15557-TUL-XX-XX-RP-C-91002 Issue 01

Land East of Longwater Road, Finchampstead, Longwater Road, Wokingham, RG40 3TS.

Discharge of Condition Consultation (Application Number 260289)

Planning Response for Conditions 7, 9 & 11.

Delivery Van Swept Path On The Straight Section of The Road

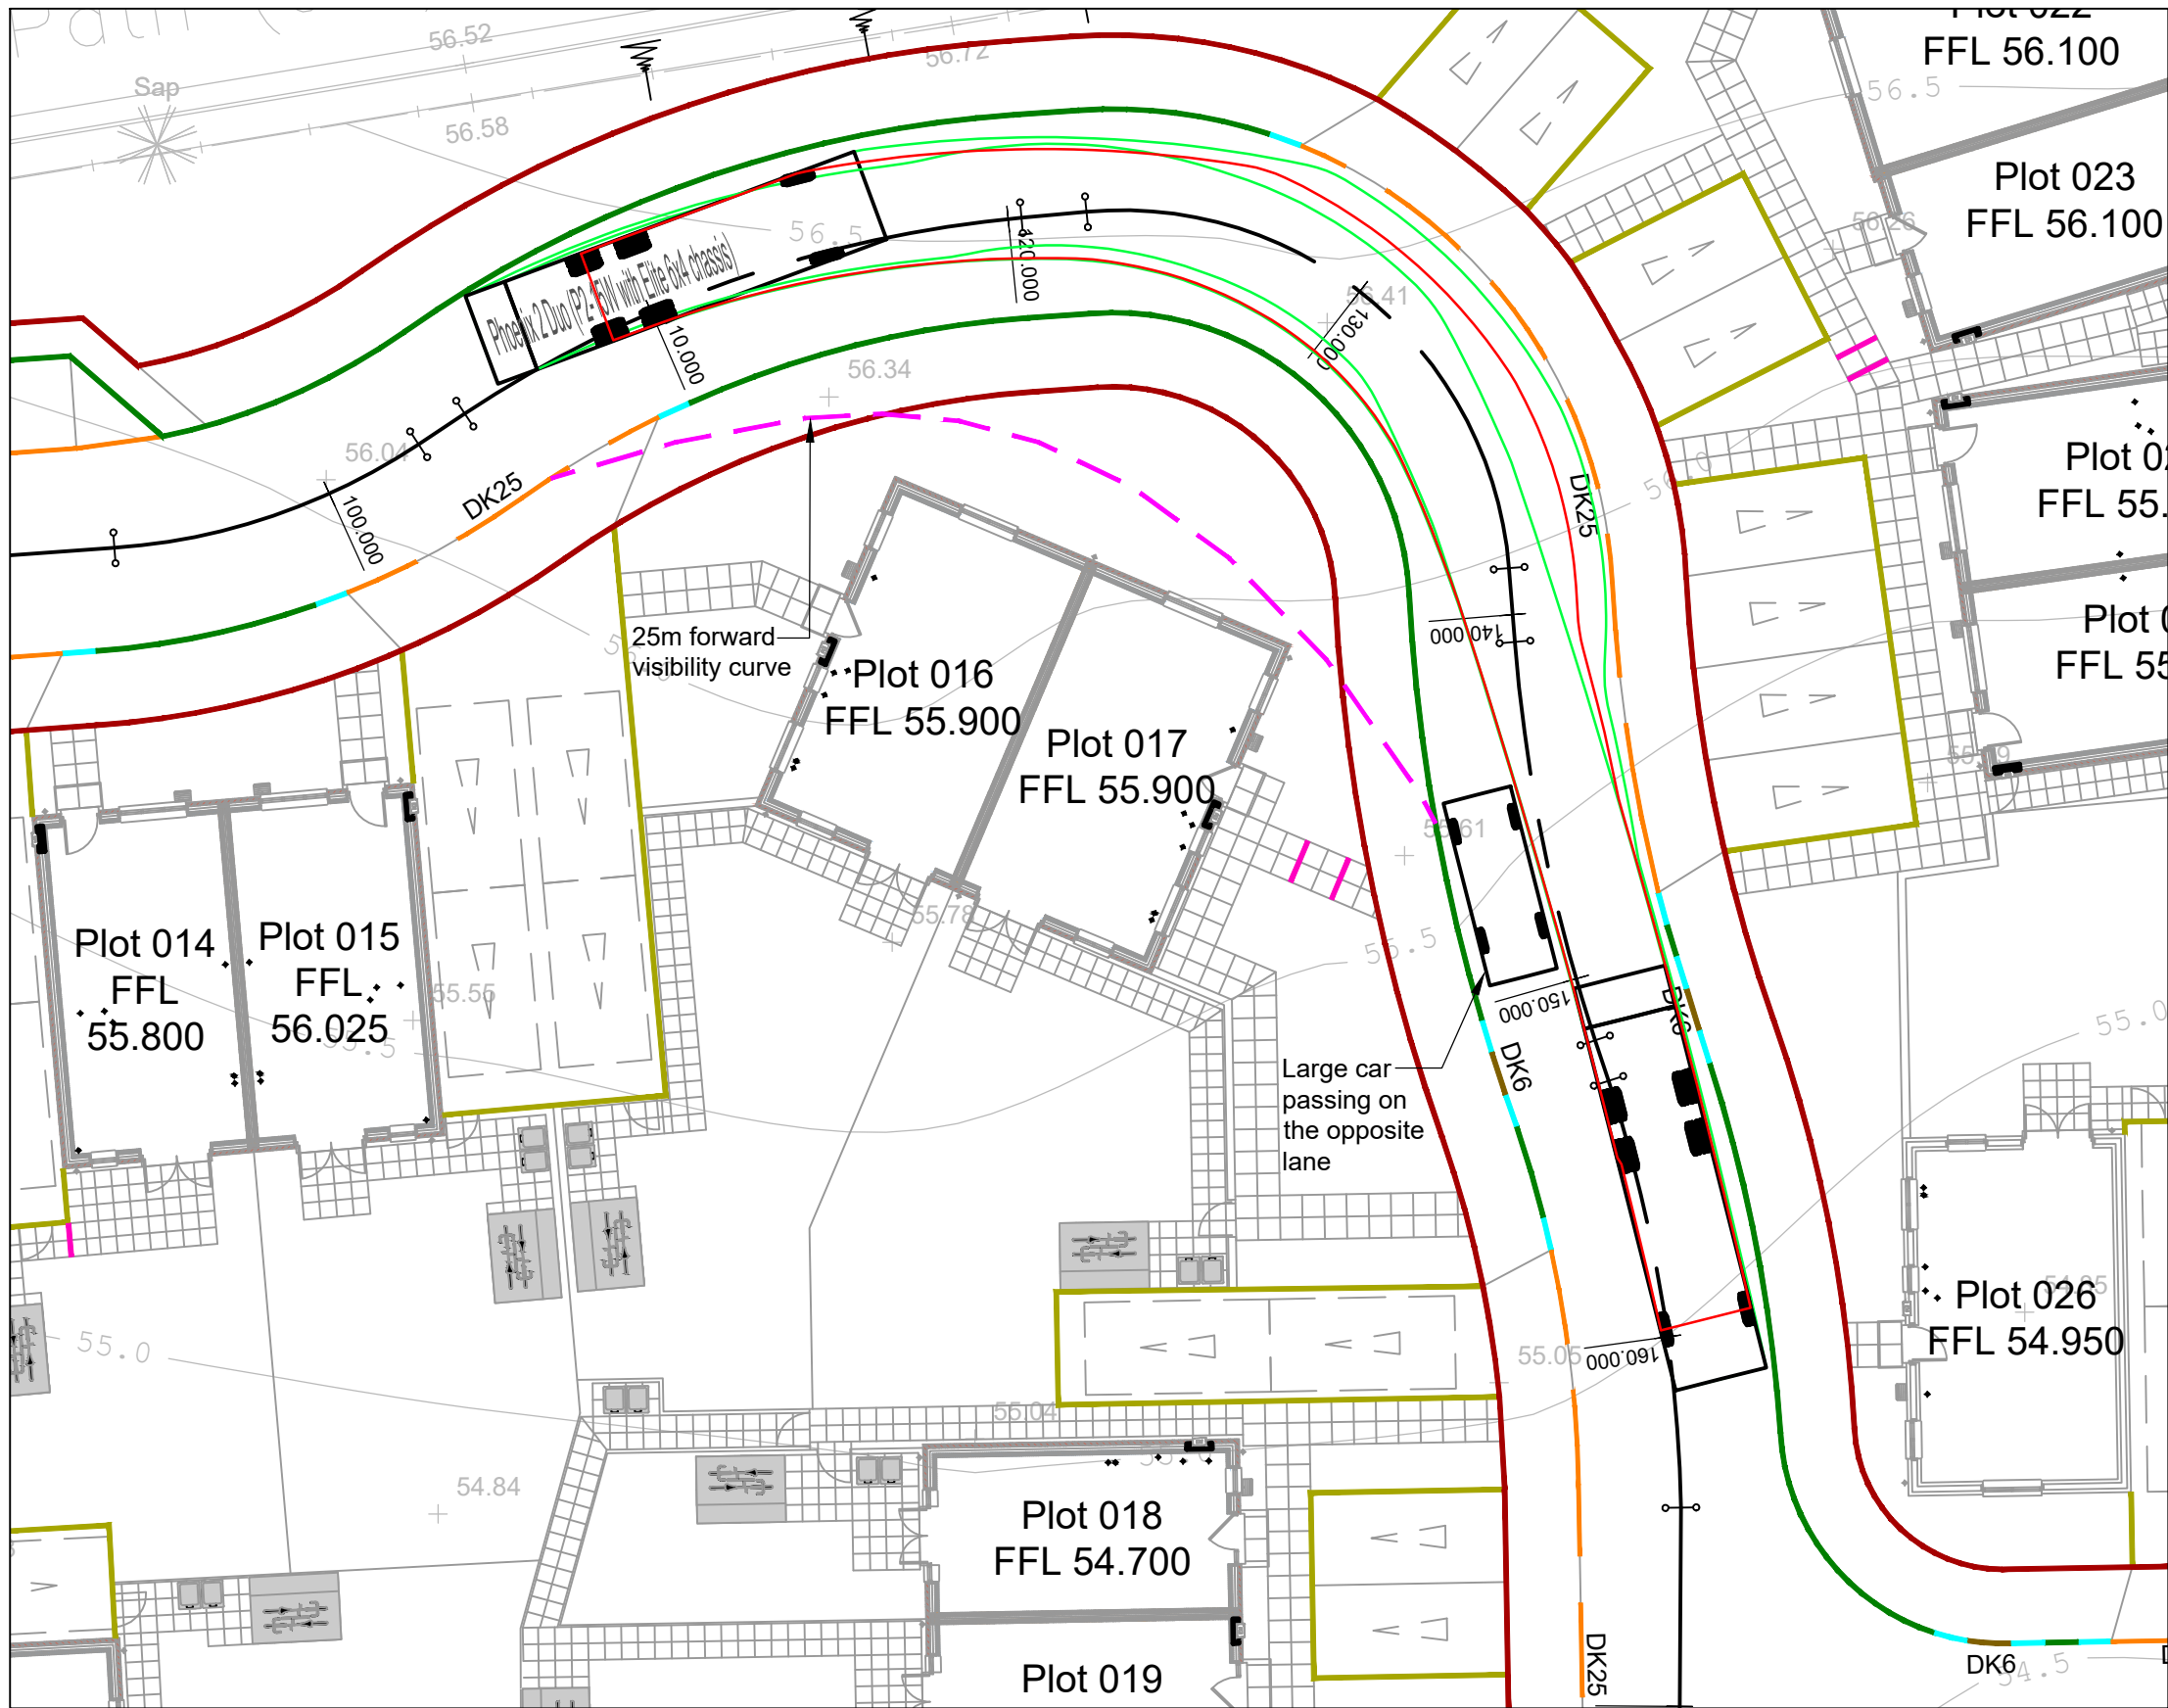
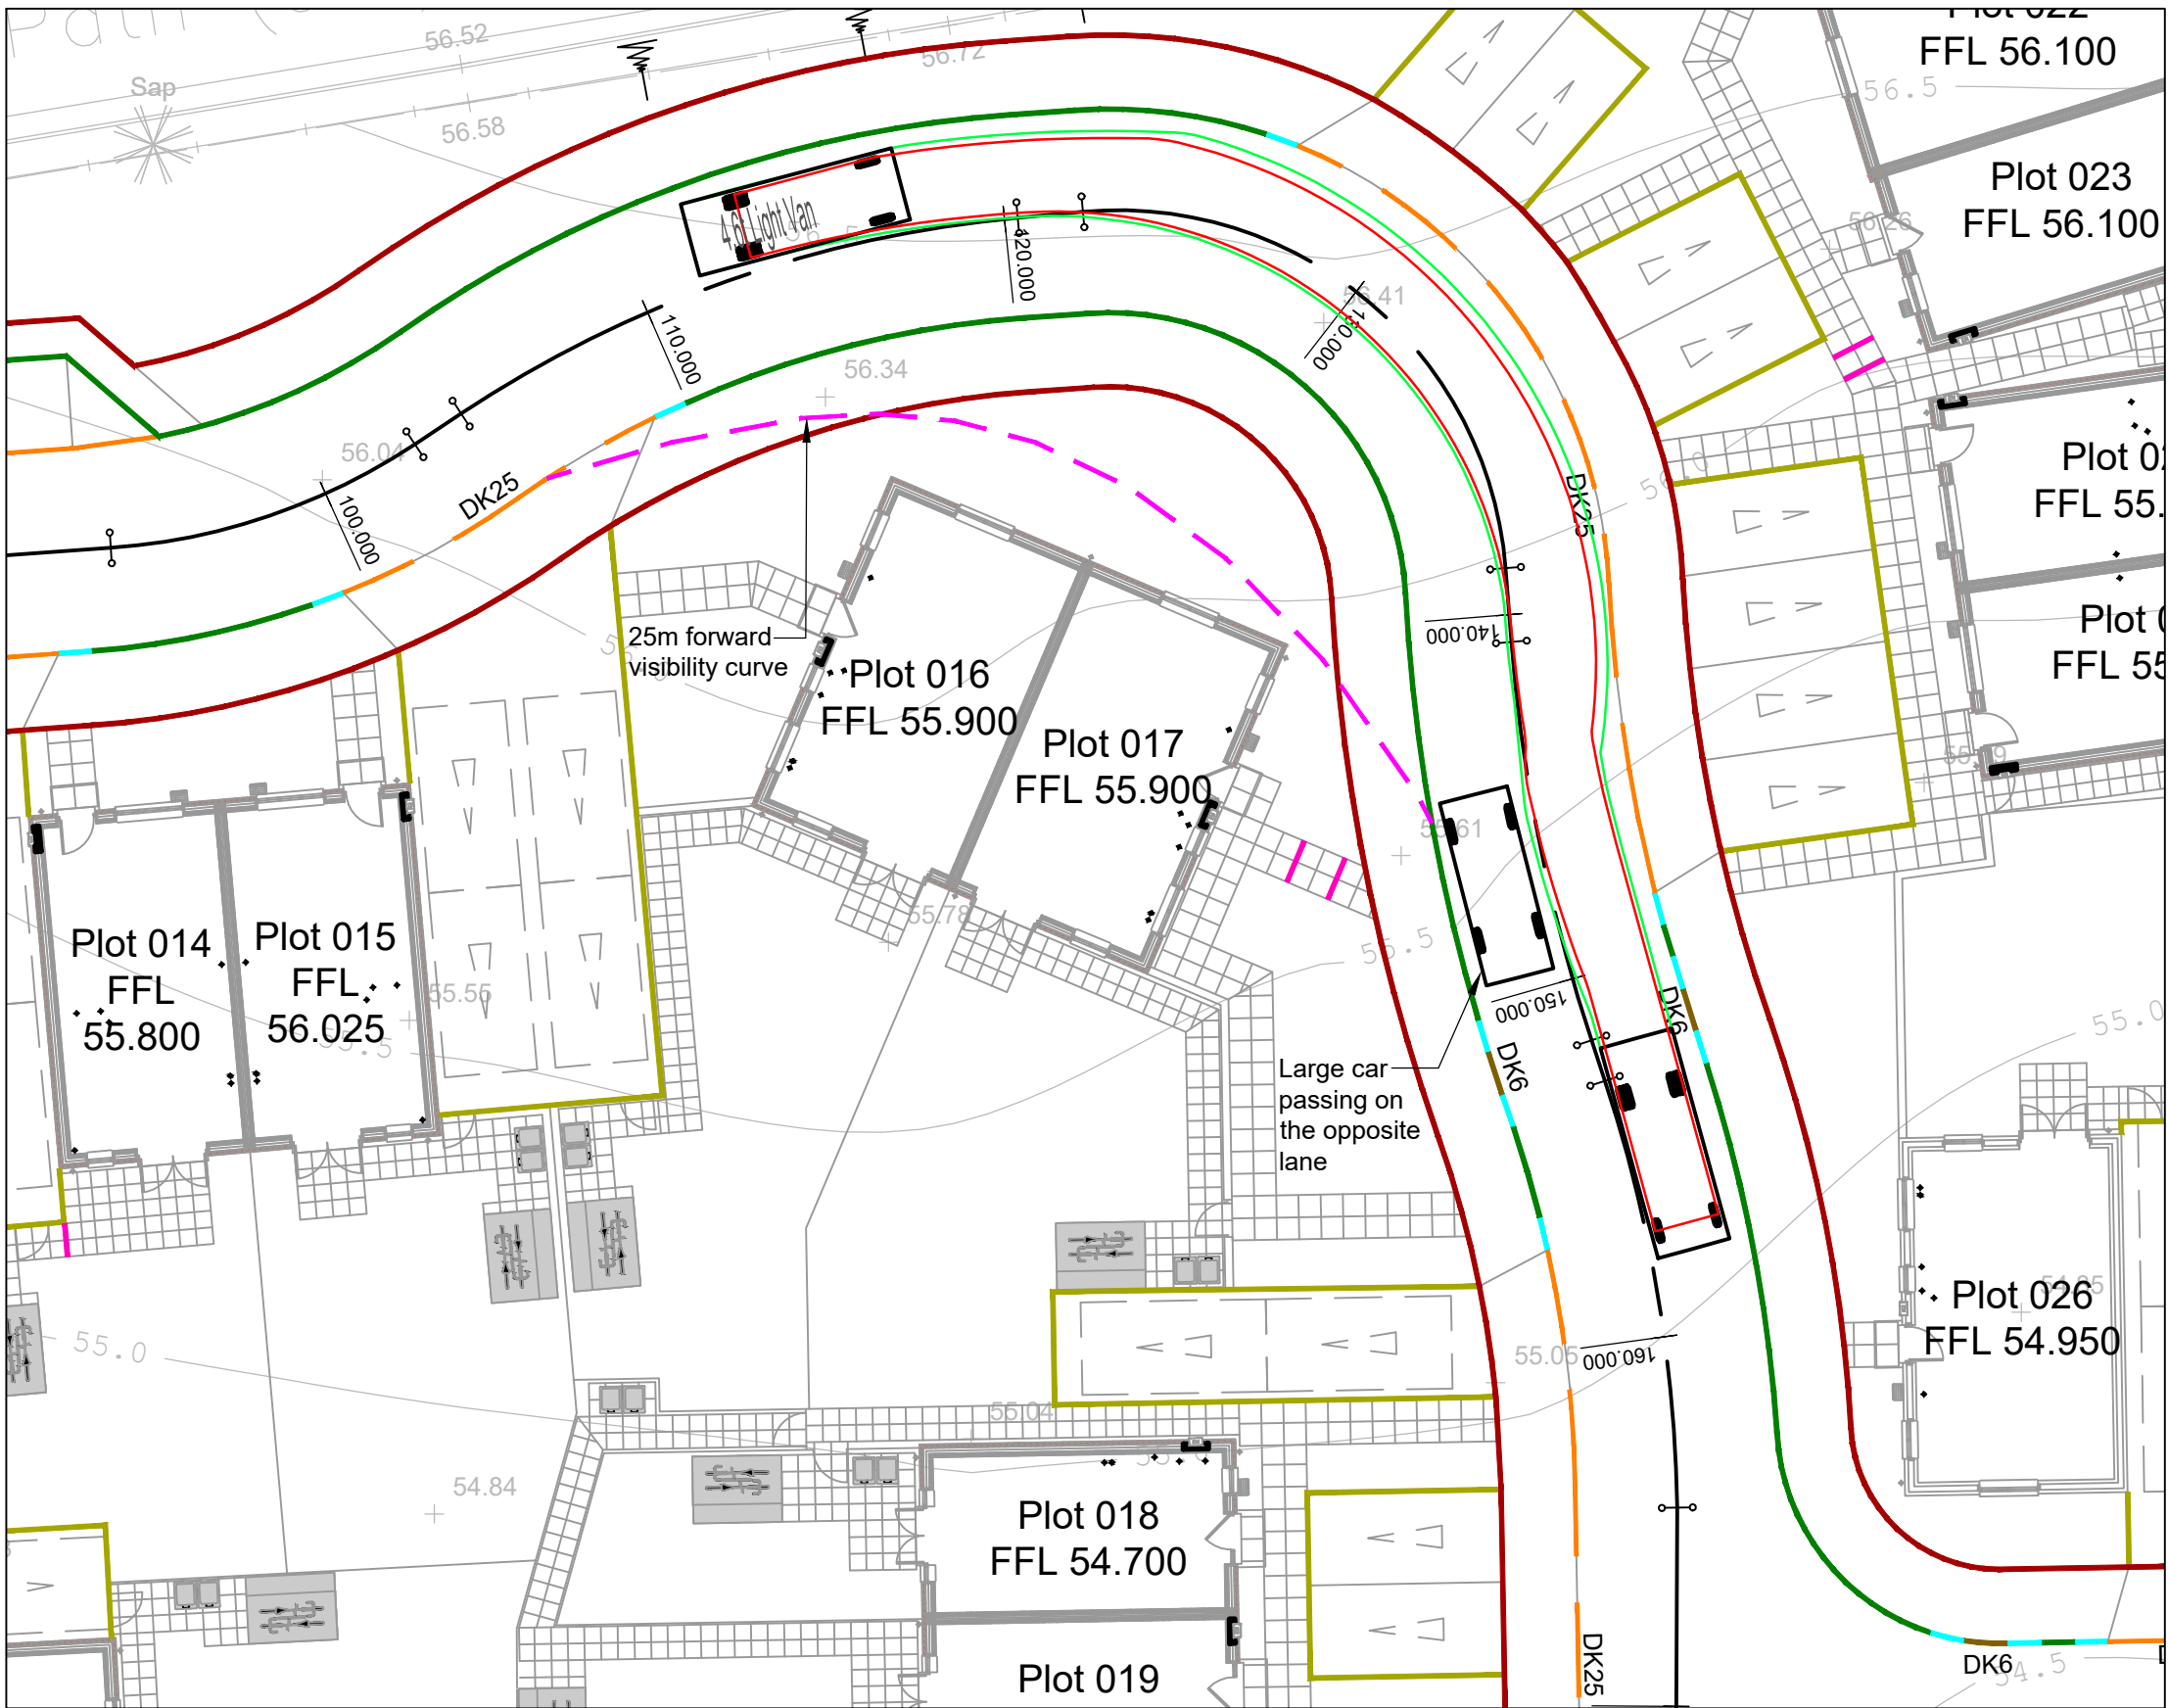
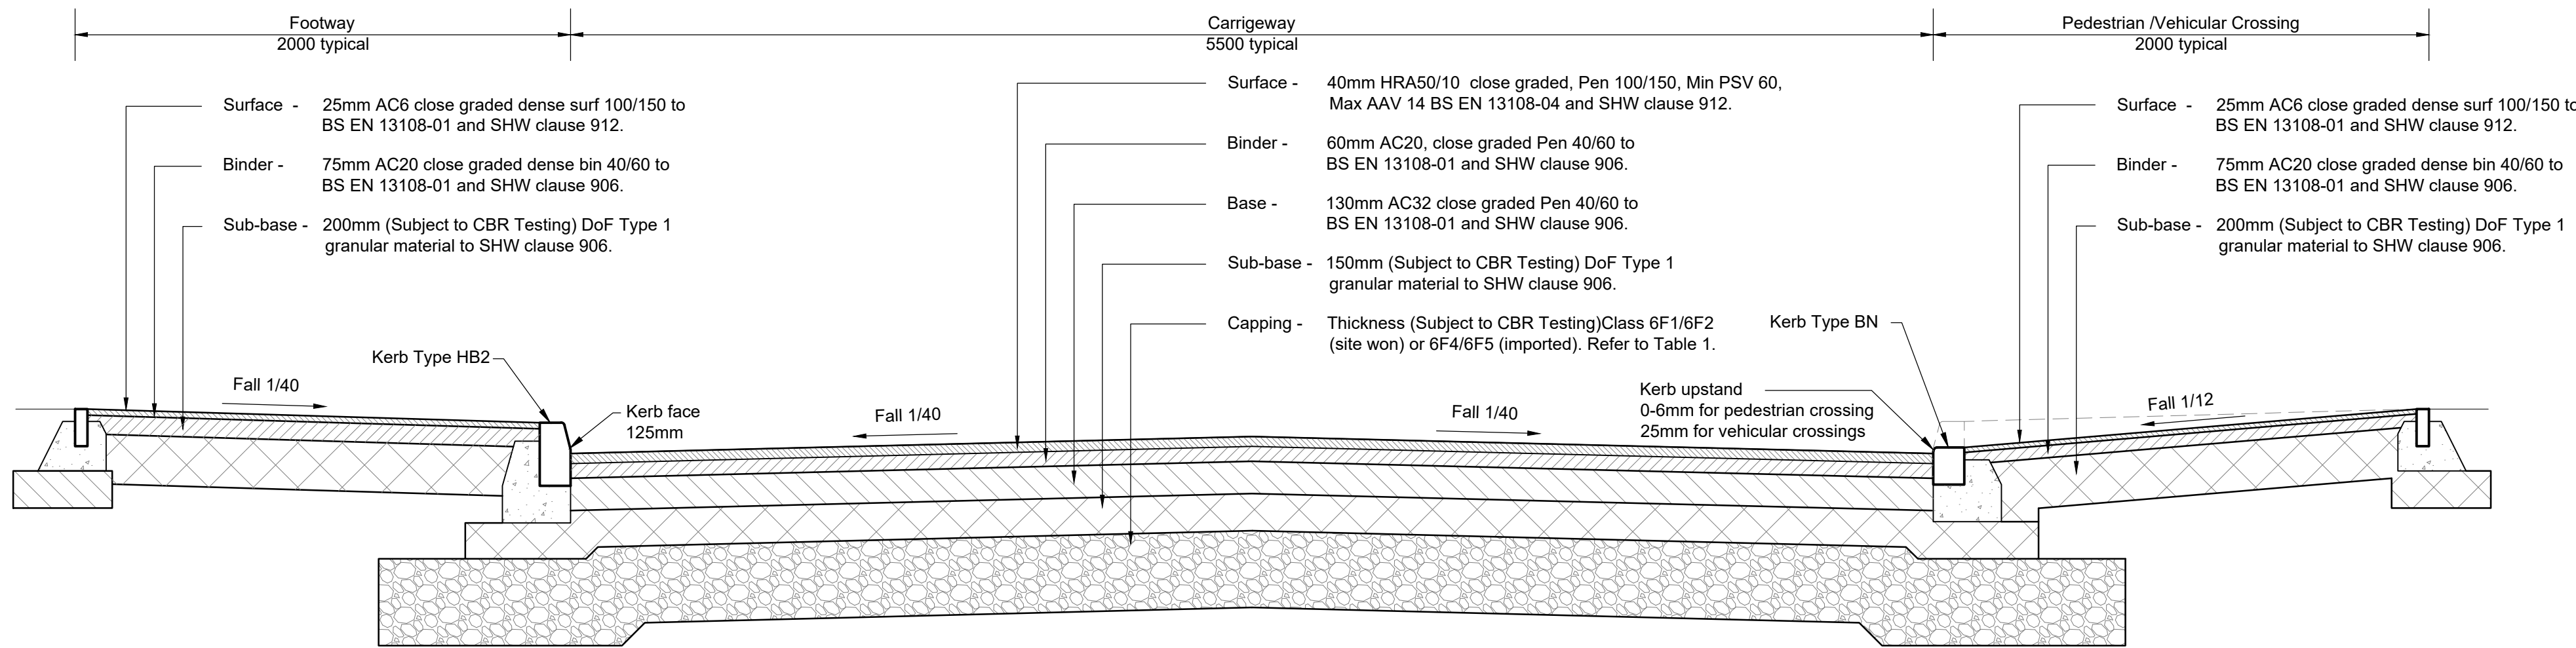
- *Width of the parking bays proposed on site should be clarified/confirmed.*
- *Swept path analysis is required for the internal roads which show a refuse vehicle and delivery van can pass a large modern car. Swept paths for a large modern car should also be completed for the car parking spaces proposed on site.*

- *Forward visibility cannot be checked at bends without the submission of swept path analysis.*
- *Haunching needs to extend past the edging.*
- *All conduits to be SD4 instead of SD2.*

- Swept paths provided for refuse vehicle and delivery van passing and car for parking spaces.

Refer to drawings GUI003-TUL-XX-00-DR-C-95-325_P01, GUI003-TUL-XX-00-DR-C-95-326_P01.

- Forward visibility curve added.

Refer to drawing GUI003-TUL-XX-00-DR-C-95-326_P01.
